DART AEROSPACE APICAL INDUSTRIES, INC. dba DART AEROSPACE	ENGINEERING CHANGE NOTICE NO. 04859	SHEET 1 OF 1
	DWG NO. 41228-301-007 · REV: D · PREPARED BY R.FUENTES · DATE: 15/05/21	EFFECT ON DWG ☐ INC. ☒ UNINC.
	DWG TITLE: INSTALLATION DRAIN EXTENSIONS	
	APPROVED BY: ENGR · MFG · QC	EFF: CURRENT ORDER
TRANSACTION CODES (TC): A-ADD C-CREATE R-REVISE D-DELETE	REASON: HOSES AVAILABLE BY VENDORS & UPDATE MIL-SPEC; REVISE CLAMP P/N & MFG	ECR:
		ACTION LIST: 1.

TITLE
INSTALLATION
DRAIN EXTENSIONS

DWG. NO. 41228–301–007 | REV. D

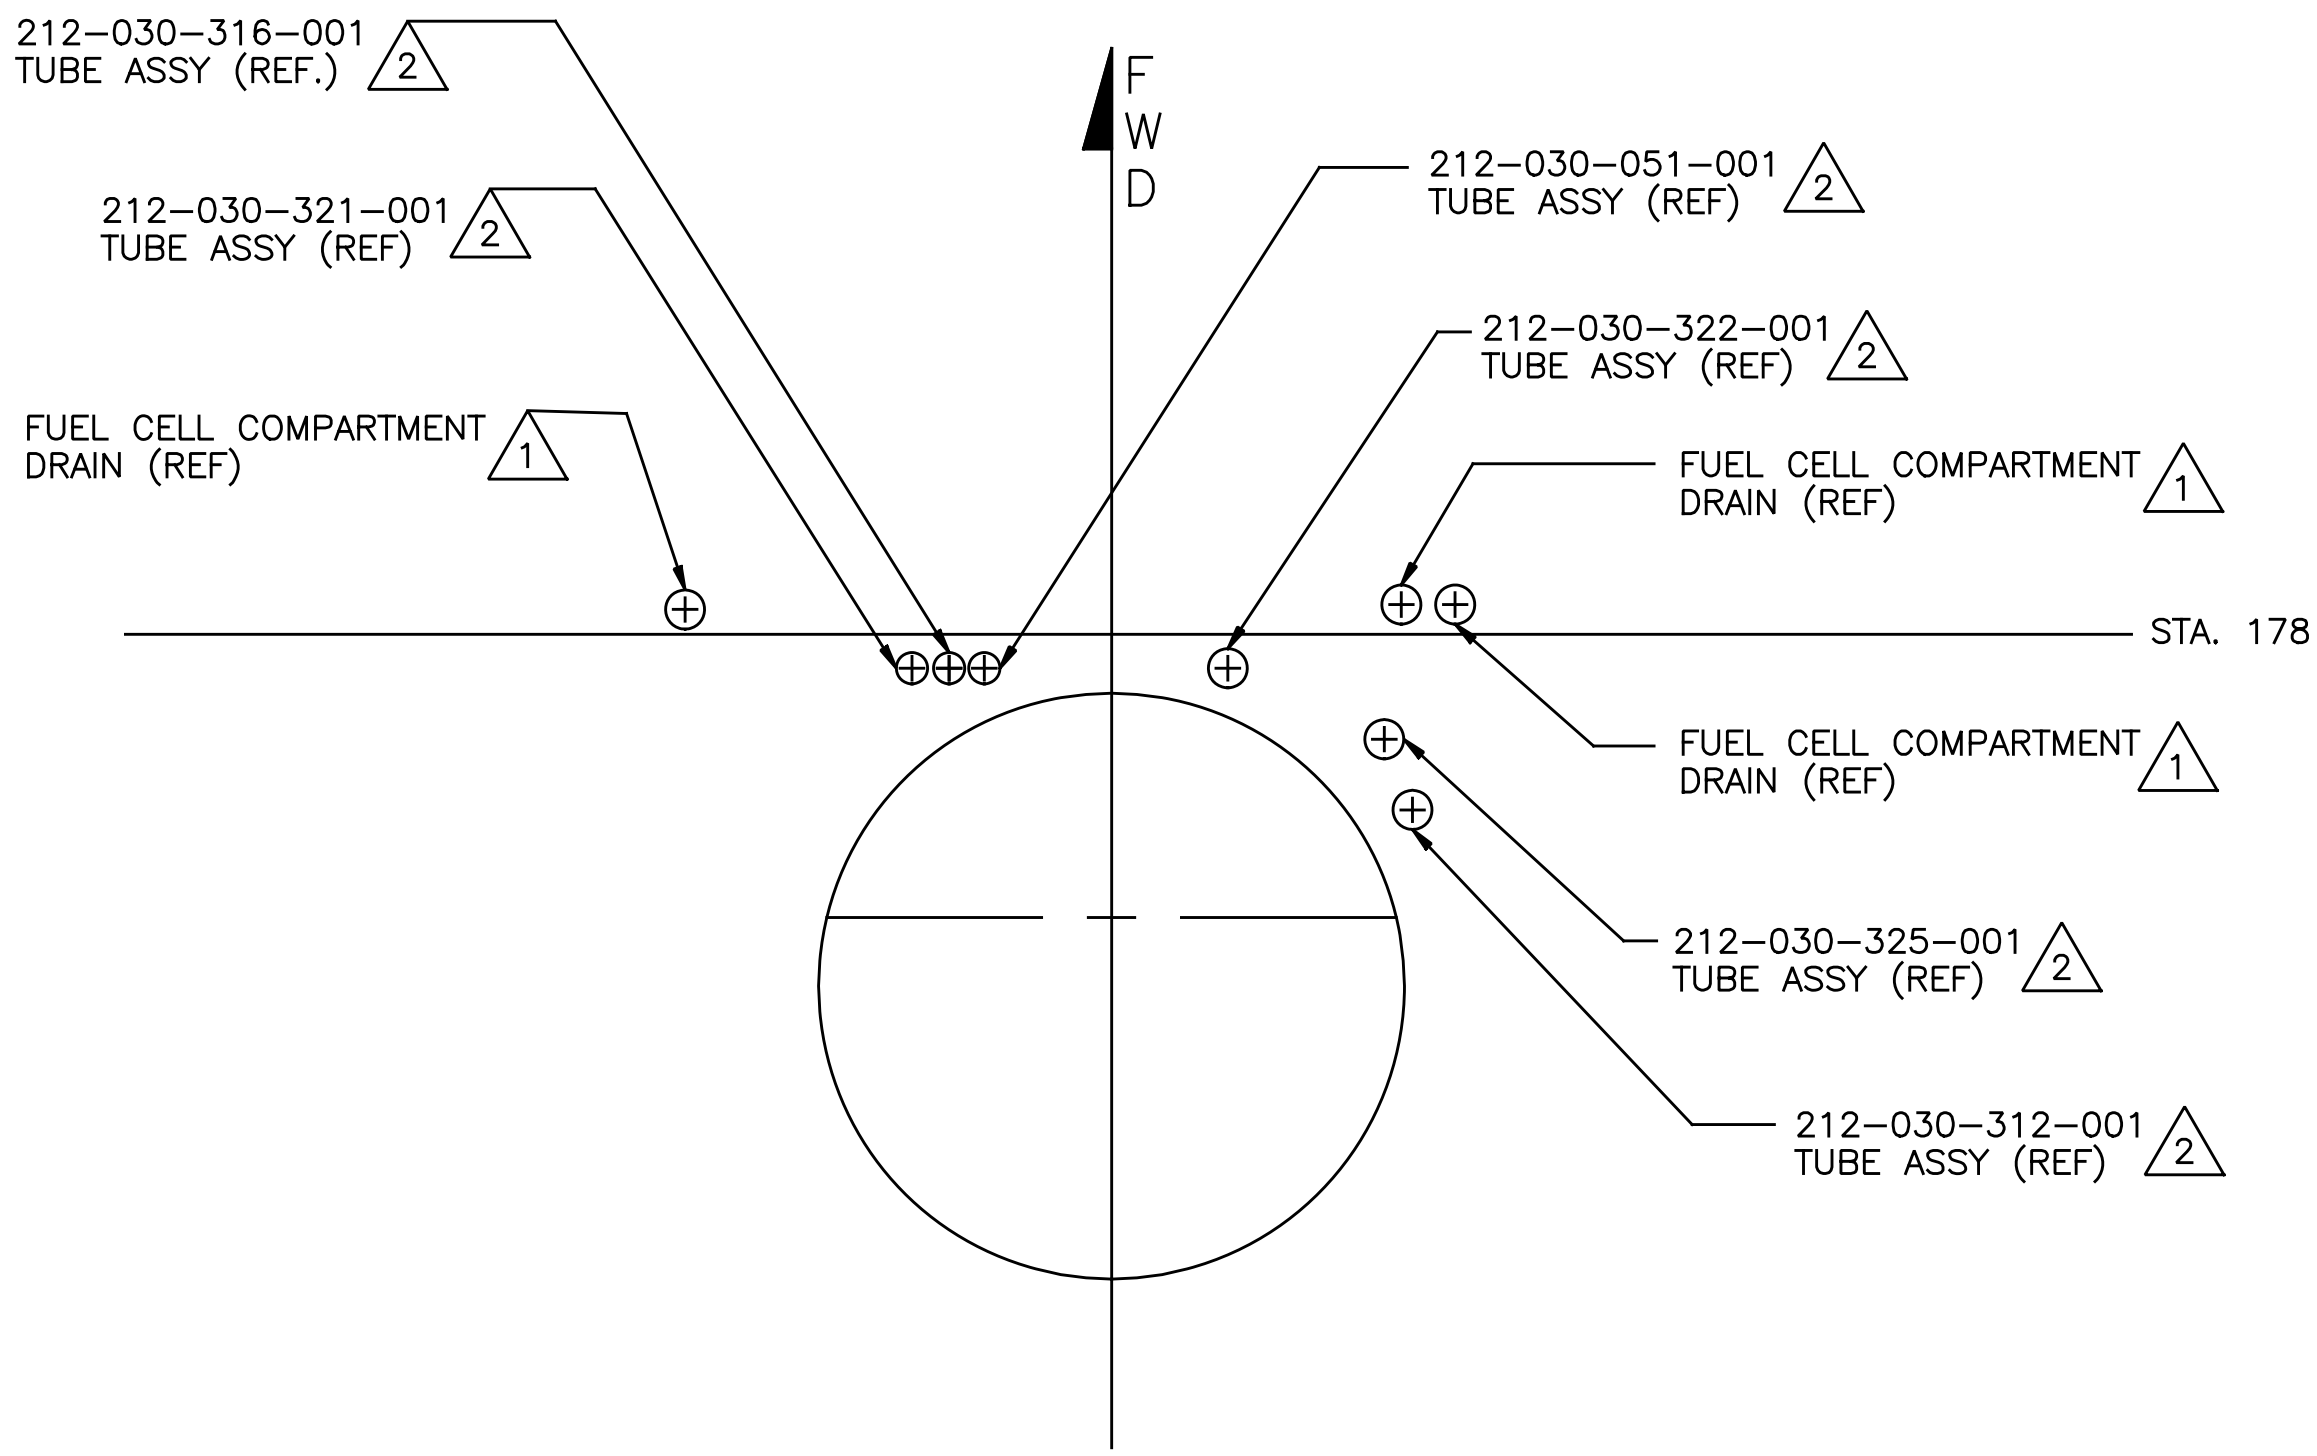
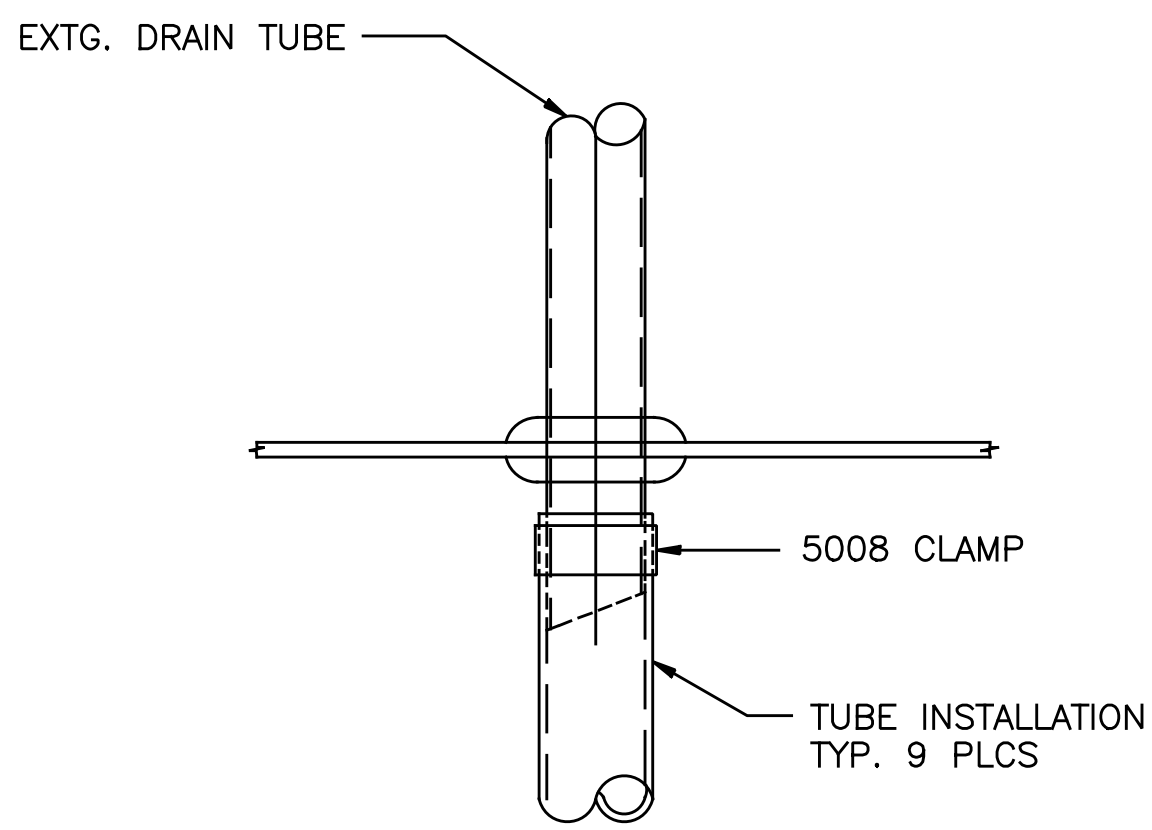
WAS

9		5008	CLAMP	PARKER HANNIFIN CORP.			
6		-003	TUBING	4.1 x 0.75 O.D. x 0.62 I.D.	RUBBER	MIL-N-6000	
3		-002	TUBING	4.1 x 0.75 O.D. x 0.50 I.D.	RUBBER	MIL-N-6000	
-001	FIND NO.	PART NO.	NAME	STOCK SIZE	MATERIAL	MATL. SPEC.	ZONE

IS

9		TLY154	CLAMP	SCN Industrial (Mfg. No. DHC5-12)			
6		-003	TUBING	4.1 x 1.00 O.D. x 0.63 I.D.	RUBBER	MIL6000D or LATER	
3		-002	TUBING	4.1 x 0.88 O.D. x 0.50 I.D.	RUBBER	MIL6000D or LATER	
-001	FIND NO.	PART NO.	NAME	STOCK SIZE	MATERIAL	MATL. SPEC.	ZONE
